DART AEROSPACE LTD		Work Order:	97650
Description: Crosstube Assembly (206B High Fwd)		Part Number:	D206-667-141
Inspection Dwg: D206-667-141 Rev: C		Page 1 of 2

DRAWING NO. D206-667-141	TITLE CROSSTUBE ASS'Y (206B HIGH FWD)	REV. C	DART AEROSPACE LTD ENGINEERING ORDER		D.E.O. NO. D206-667-141-C-1	SHEET NO. SHEET 1 OF 1	SCALE NTS
DRAWN <i>qp</i>	CHECKED <i>ASS</i>	MFG. APPR. <i>MD</i>	APPROVED <i>MD</i>		DE APPR. <i>MD</i>		
DATE 11.07.15	DATE 11.07.20	DATE 11.07.21	DATE 11/07/21		DATE 11.07.21

DRAWING NO. D206-667-141	TITLE CROSSTUBE ASS'Y (206B HIGH FWD)	REV. C	DART AEROSPACE LTD ENGINEERING ORDER		D.E.O. NO. D206-667-141-C-2	SHEET NO. SHEET 1 OF 1	SCALE NTS
DRAWN AJS	CHECKED J	MFG. APPR. E	APPROVED AP		DE APPR. H		
DATE 12.08.02	DATE 12.08.02	DATE 12.08.02	DATE 12.08.02		DATE 12-08-02

DETAIL P
BONDING STRAP INSTALLATION 2 PL

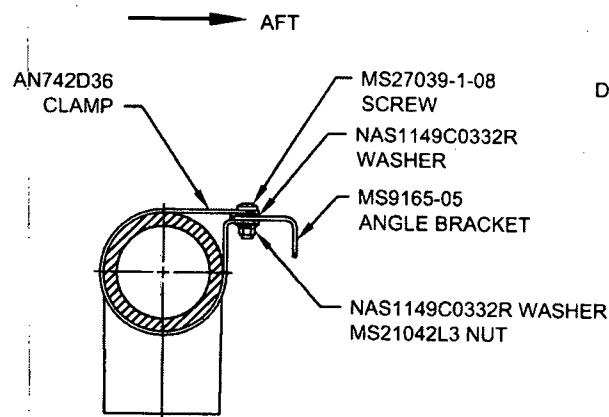
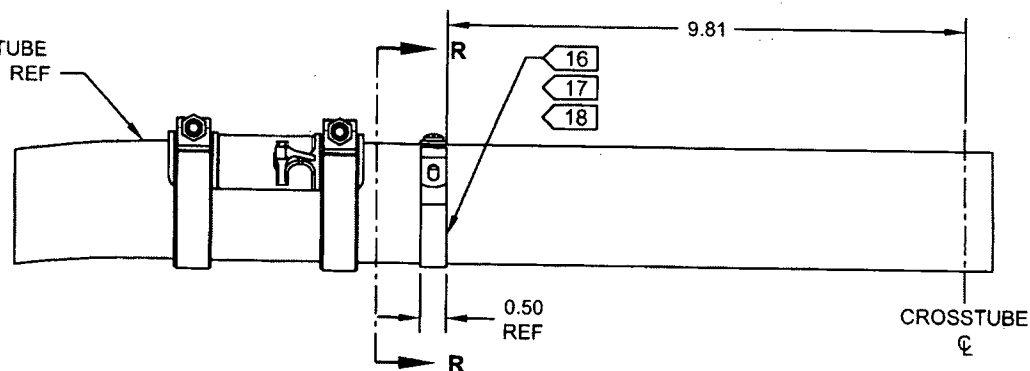
ADD ELECTRICAL GROUNDING STRAP

ADD

- 16) MASK AREA UNDER CLAMP PRIOR TO PAINTING
- 17) SEAL EDGES WHERE AN742D36 CLAMP MEETS WITH THE CROSSTUBE USING SIKAFLEX-241/-291 OR MIL-S-8802 CLASS B2 OR PROSEAL 890 SEALANT
- 18) PERFORM RESISTANCE CHECK TO ENSURE MAX RESISTANCE IS 10 MILLIOHMS
